# Assessment of Dam Safety Coal Combustion Surface Impoundments Draft Report

American Electric Power  
General James Gavin  
Power Plant  
Cheshire, Ohio

July 2, 2009

CHA Project No. 20085.4000.1510

FIGURE 9B

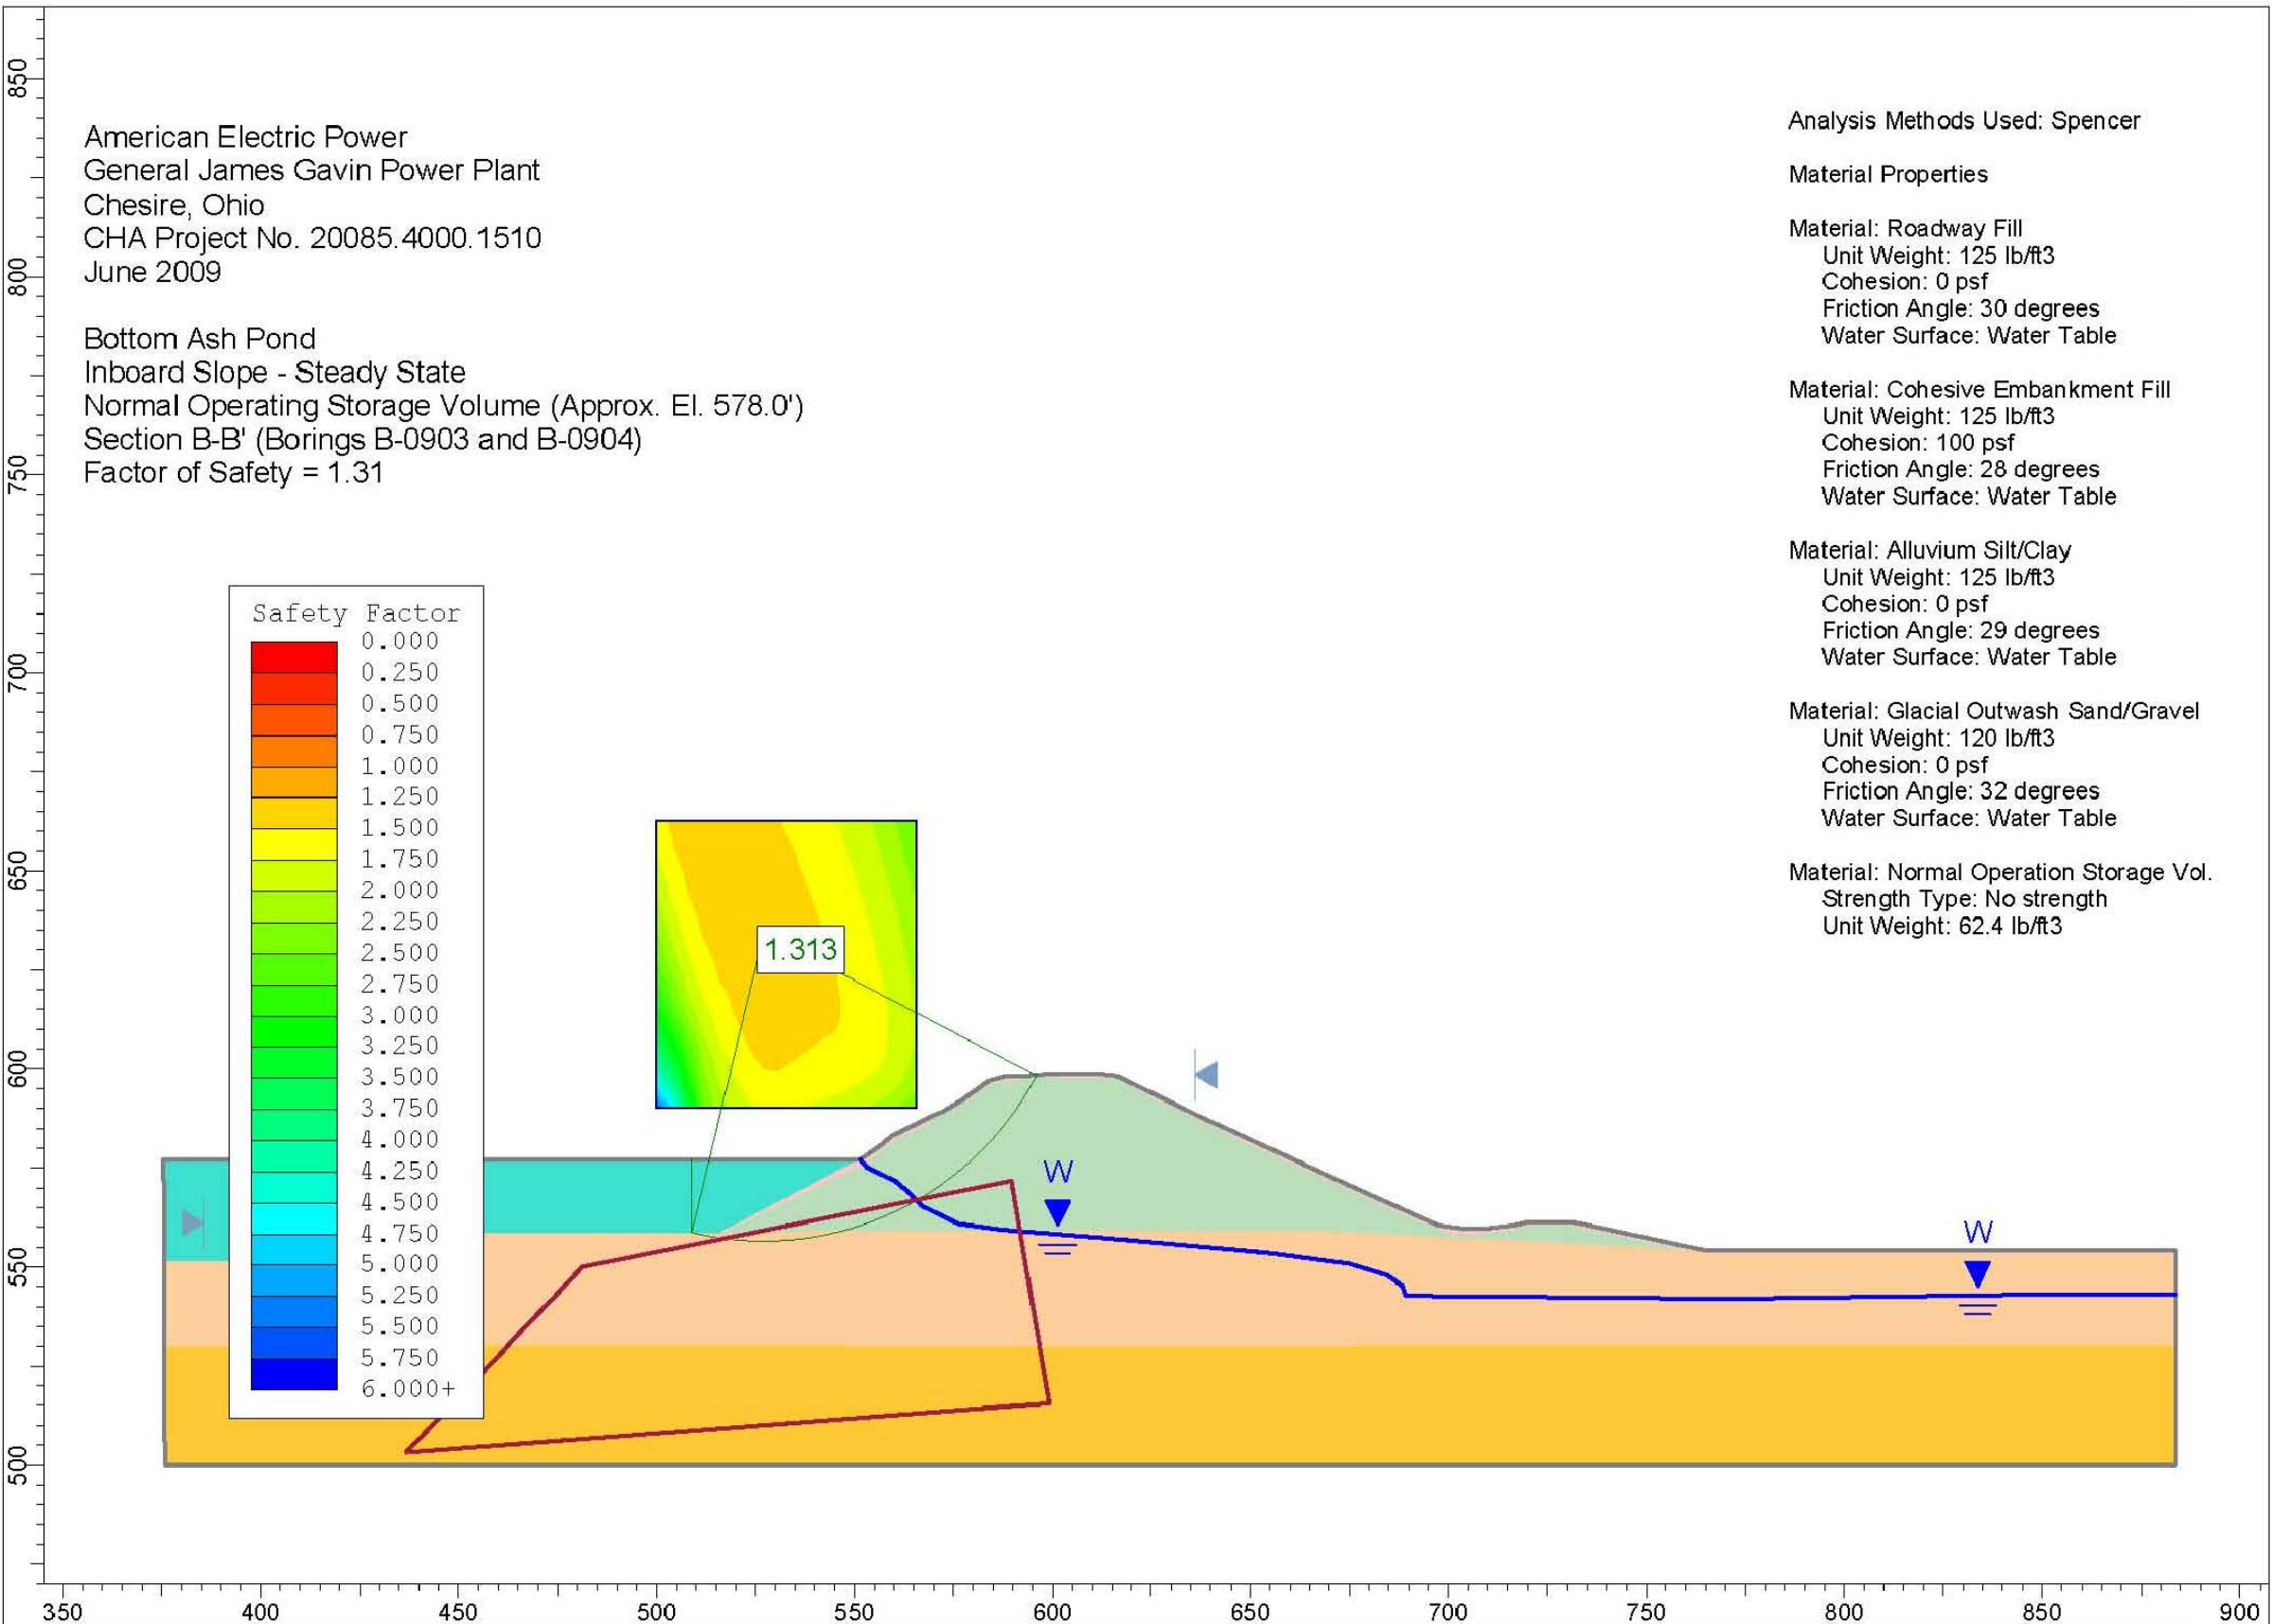
- The factor of safety for the upstream (inboard) embankment slope of the pond was not evaluated as part of BBCM's June 2009 investigation. CHA modeled the upstream slope using the south embankment geometry and the steady state loading condition (see Figure 9B) and the soil parameter provided in BBCM's report. The calculated factor of safety was 1.3 which is below the minimum required factor of safety (according to the USACOE).

CHA recommends the upstream slope be re-graded to correct the steepness and slumped areas for stabilization. This effort should be coordinated with the recommendations made in Section 4.11 to analyze the upstream slope.

FIGURE 9C

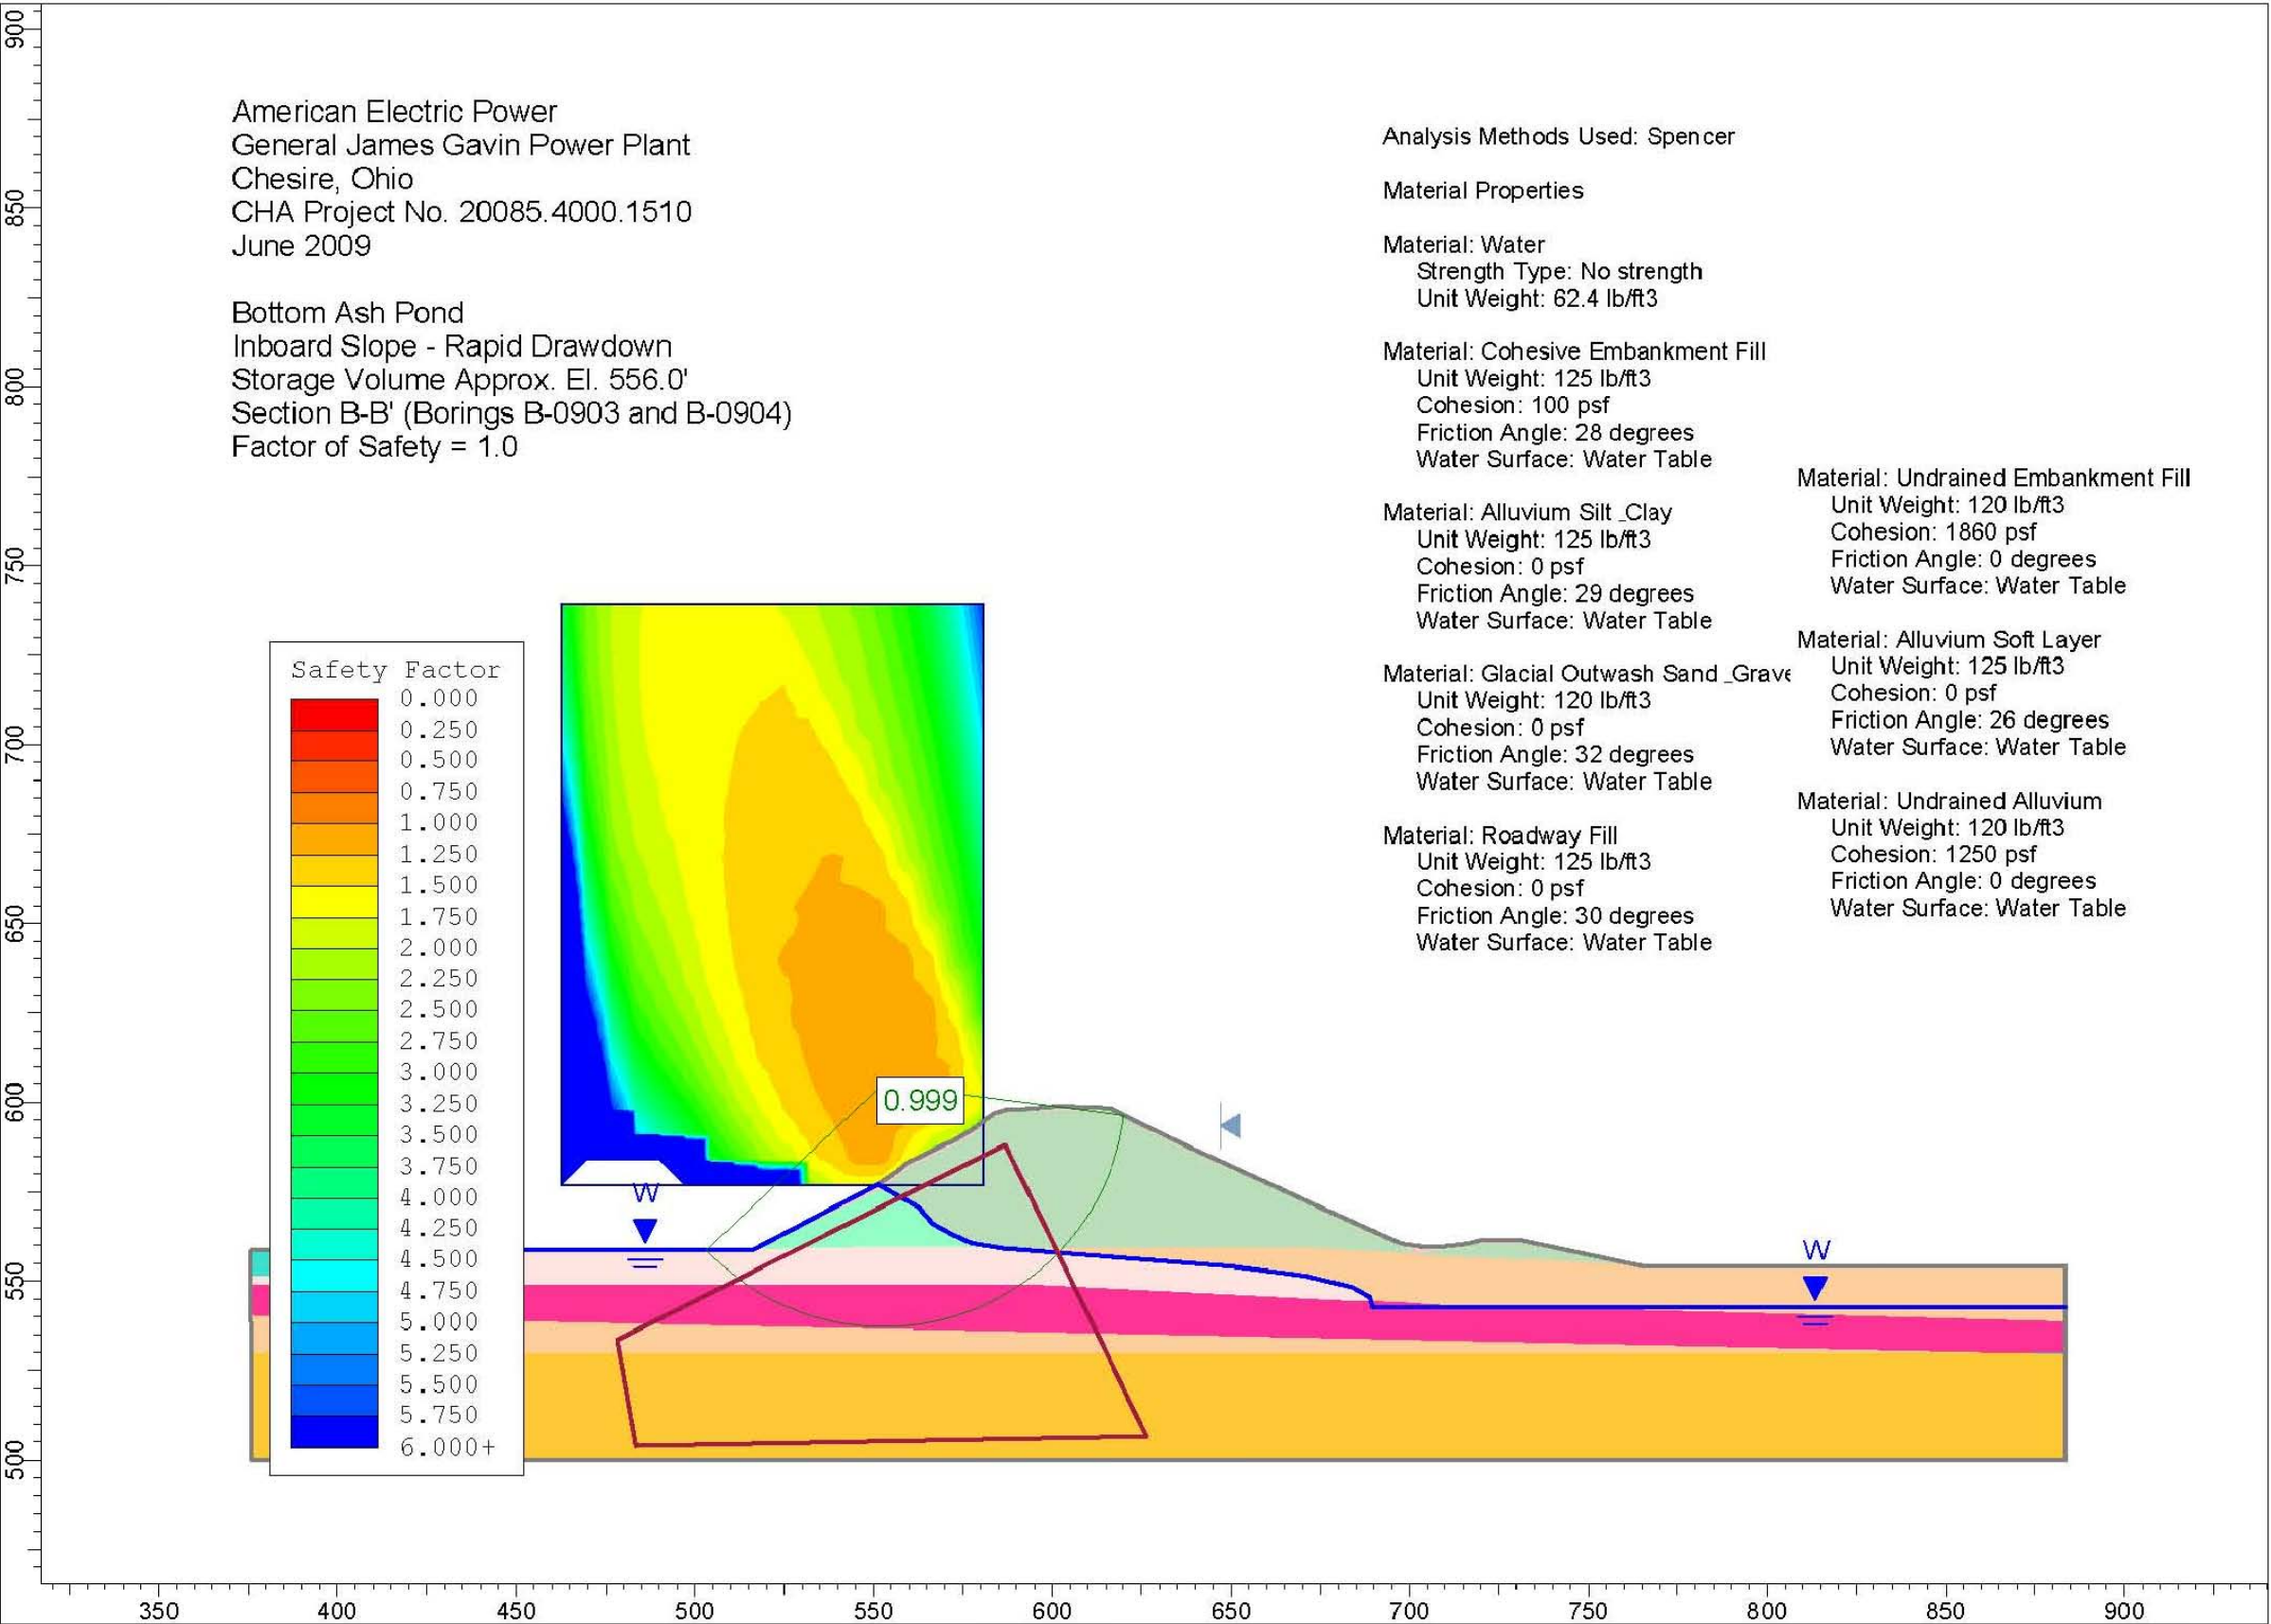
- The rapid-draw down load case was not evaluated as part of the June 2009 investigation. CHA modeled the south embankment slope using a combination of soil parameters provided in the June 2009 investigation report and parameters which may more closely represent field conditions (i.e. undrained embankment and alluvium soils on the upstream slope and a softer alluvium silt/clay layer). Figure 9C indicates that the calculated factor of safety for the rapid draw-down load condition is close to 1.0, which is below the minimum required value of 1.3 (according to the USACOE).
